**Development Review Committee
July 6, 2022
Council Chambers
9:00 AM**

**DM WAIVER REQUEST
142 S. SWOOPE AVENUE
DEVELOPMENT REVIEW COMMITTEE (DRC)
JULY 6, 2022**

Maitland Concourse North Lot 1 (2021-03 AZ-PD) Zoning Amendment for Planned Development

SHEET NUMBER
PD3.2

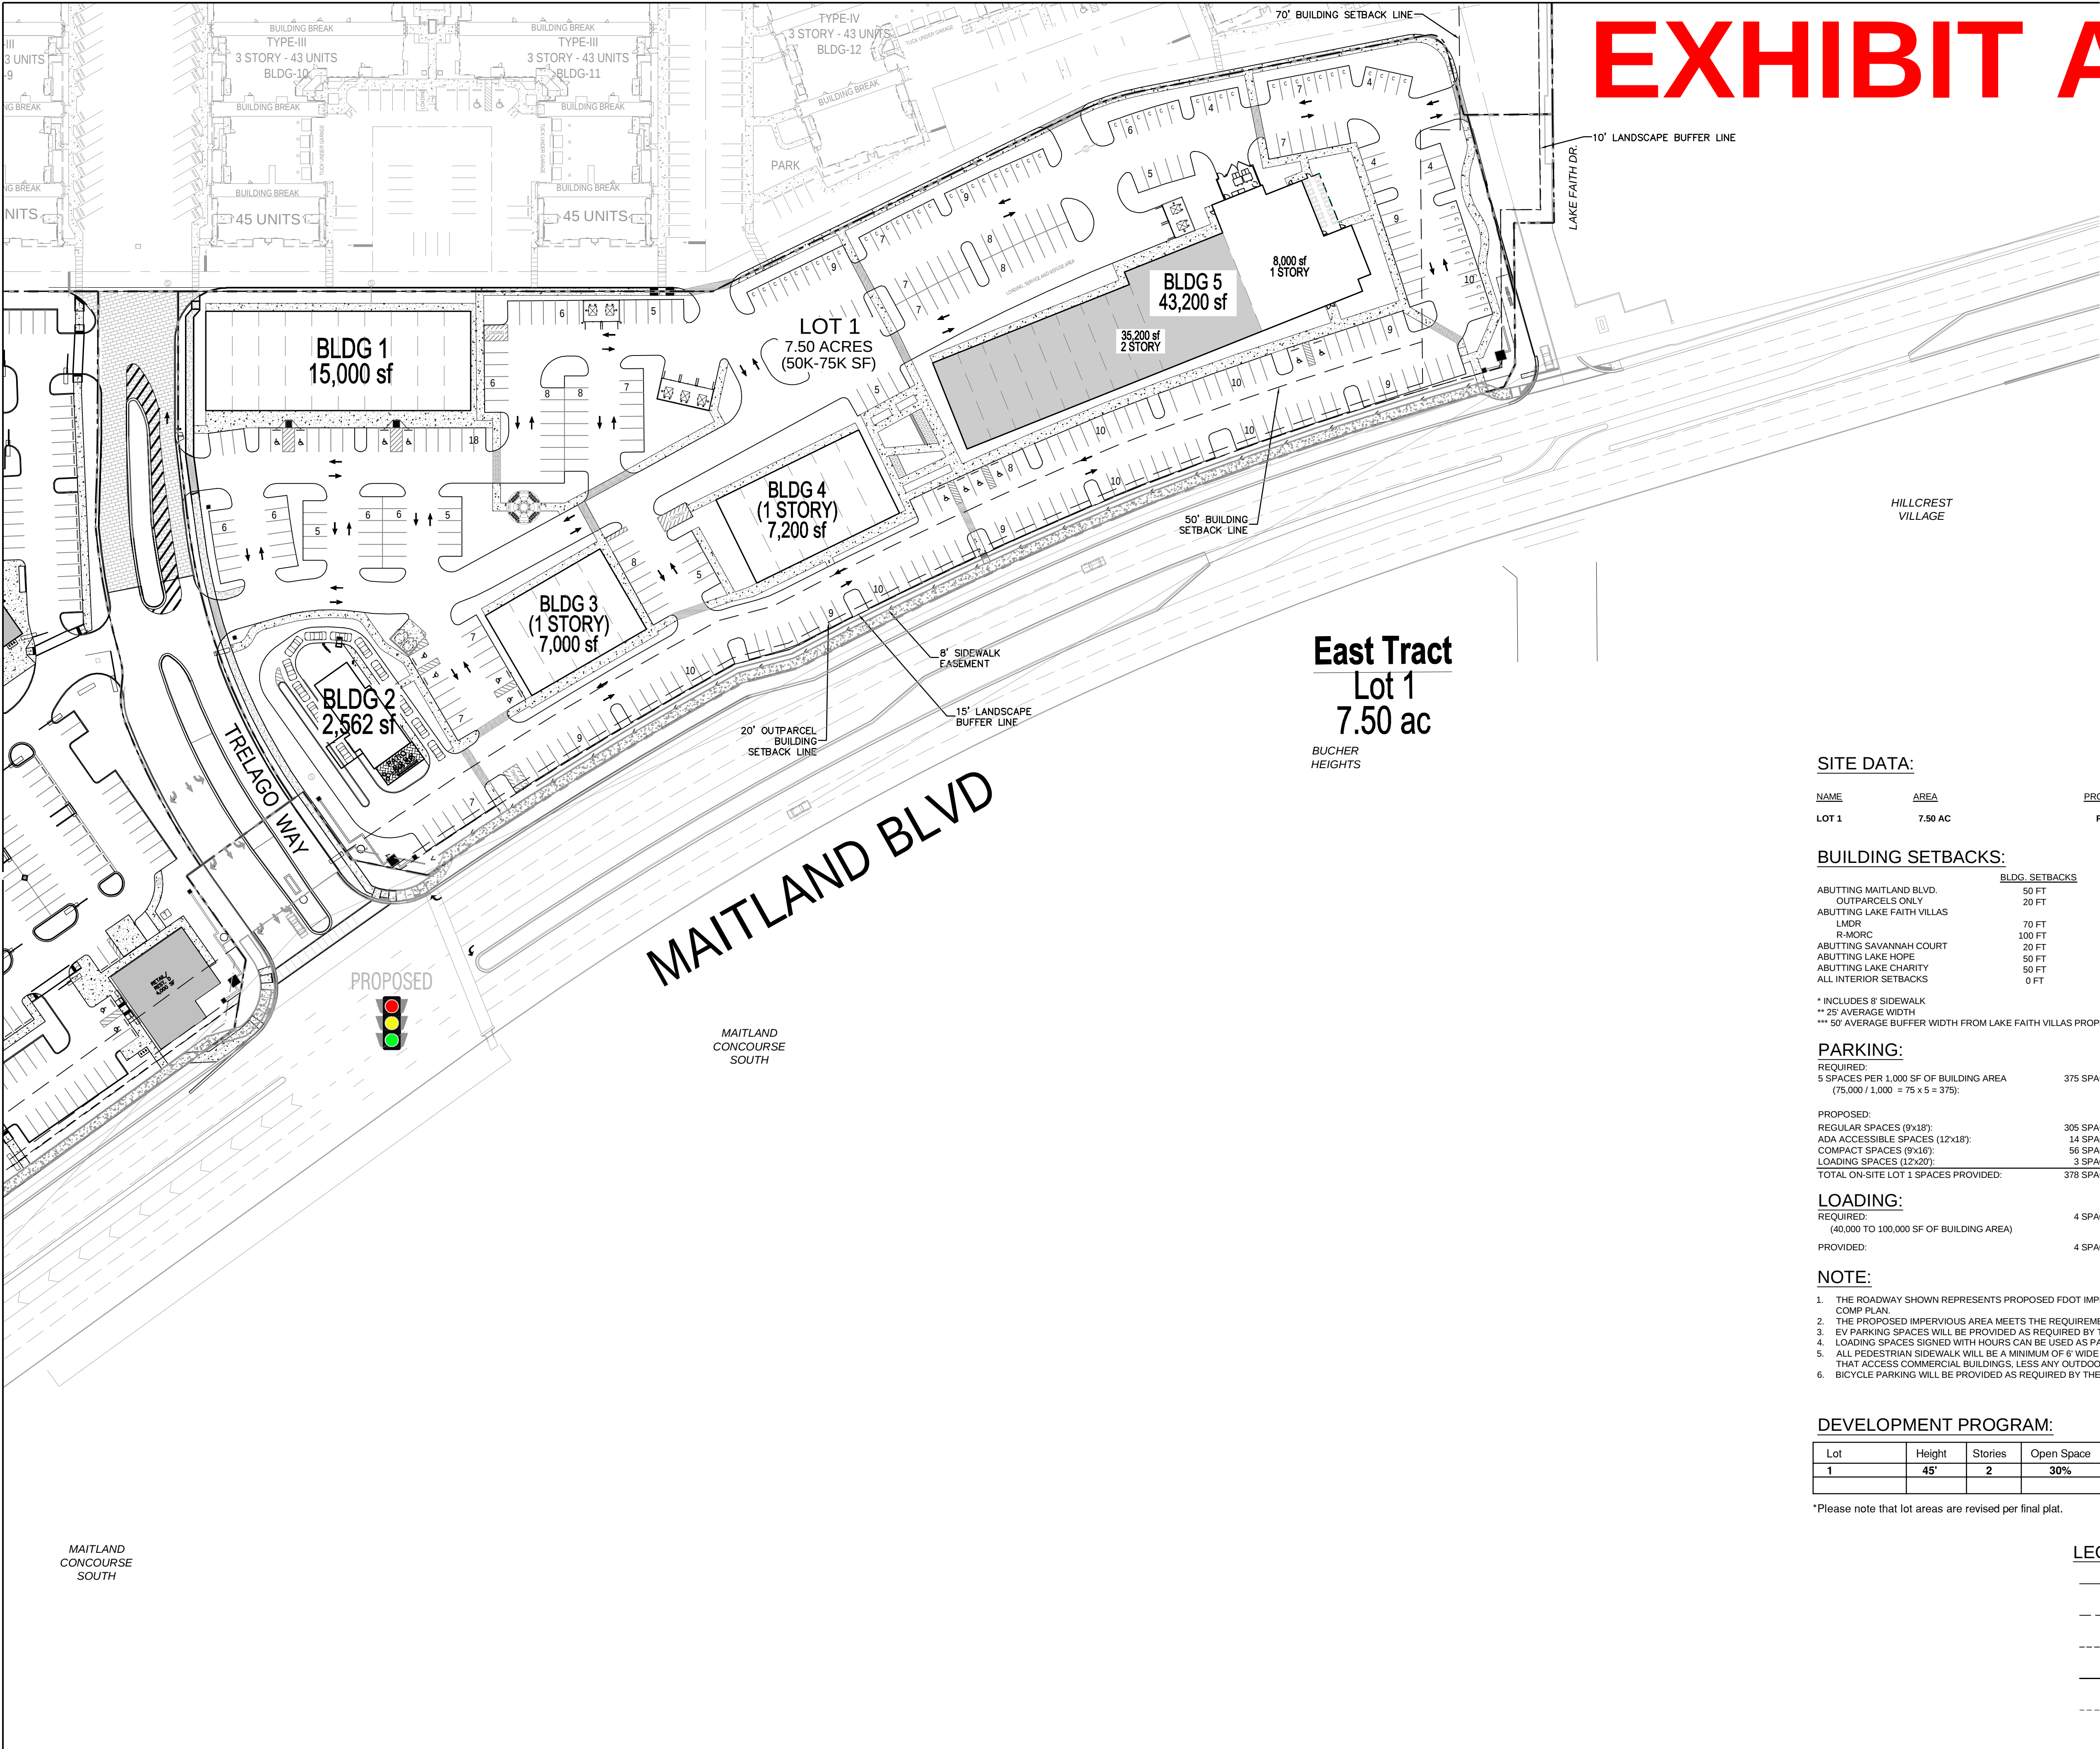
1. Consider eliminating all or several drive-through uses;

2. Consider 'curbside takeout' style digital ordering (specifically on Building 4, which seems well suited for it);

3. Enhance landscaping on eastern property boundary as buffer to residences;

4. Develop a sidewalk on Lake Faith Drive/relocate NE corner sidewalk to along perimeter (Lake Faith Drive);

5. Review potential impacts of trucks and buses on Lake Faith Drive;

6. Accommodate the existing OCPS bus stop;

7. Develop pedestrian access north of Building 5;

8. Consolidate or relocate refuse areas;

9. Utilize fully enclose dumpsters;

10. Study patterns of existing and likely pedestrian circulation and match with proposed pathways;

11. Consider if pathways accommodate bikes or other non-motorized transit as well as pedestrians;

12. Analyze percentage of area dedicated to drive-through uses, consider the percentage of frontage on Maitland Blvd dedicated to drive-through uses;

13. Review additional trip generation of drive-through uses, including consideration of proximity to interstate highway;

14. Consider noise impacts of outdoor dining; and

15. Examine whether NE access point it too close to existing E-W drive.

Response: The drive-thru was removed from Buildings 1 and 4.

Response: The drive thru was removed from Building 4.

Response: The proposed site plan allows for more landscape buffering than the previously approved LUP.

Response: A sidewalk has been added on the west side of Lake Faith Drive providing additional pedestrian connectivity to Maitland Boulevard.

Response: The proposed project has been designed to be an integrated development and all access points meet design standards.

Response: The residential uses within the PD and Lake Faith Villas needs to coordinate bus stop locations/accommodations with Orange County Public Schools.

Response: A pedestrian access is provided.

Response: The refuse areas have been consolidated where practical.

Response: All trash areas are shown fully enclosed with walls and gates.

Response: The proposed pedestrian pathways provide excellent connectivity across the site and are a result of careful consideration.

Response: All pathways are a minimum of six feet (6') wide as requested by City staff.

Response: Only one drive-thru is proposed at this time.

Response: Alternative variables were reviewed for trip generation for drive-through uses. There are no variables or adjustment factors related to proximity to interstates or highways. Since the setting/location for these uses are General Urban/Suburban, it is highly likely that many of the sites are located near interstates. However, there are no data to differentiate which sites are near an interstate and which sites are not near an interstate. The trip distribution for the site assumed the roadway network which includes I-4 and Maitland Boulevard. It is noted that pass-by and diverted link analyses are often limited to 10% of the adjacent street traffic. While this number is arbitrary and not supported by data, the pass-by assumed for the drive through uses represent approximately 2.5% percent of the traffic on Maitland Boulevard, so there is no need to consider diverted trips from I-4 above and beyond the trips using I-4 as their typical route. For long-range trips on the interstate that might be thirsty for coffee, there are options for Starbucks that are significantly closer than Maitland Concourse, for example, two options on SR 434, one on SR 436, and one on Lee Road.

Response: The project will meet the approved PD noise requirements.

Response: The proposed access points provide adequate spacing.
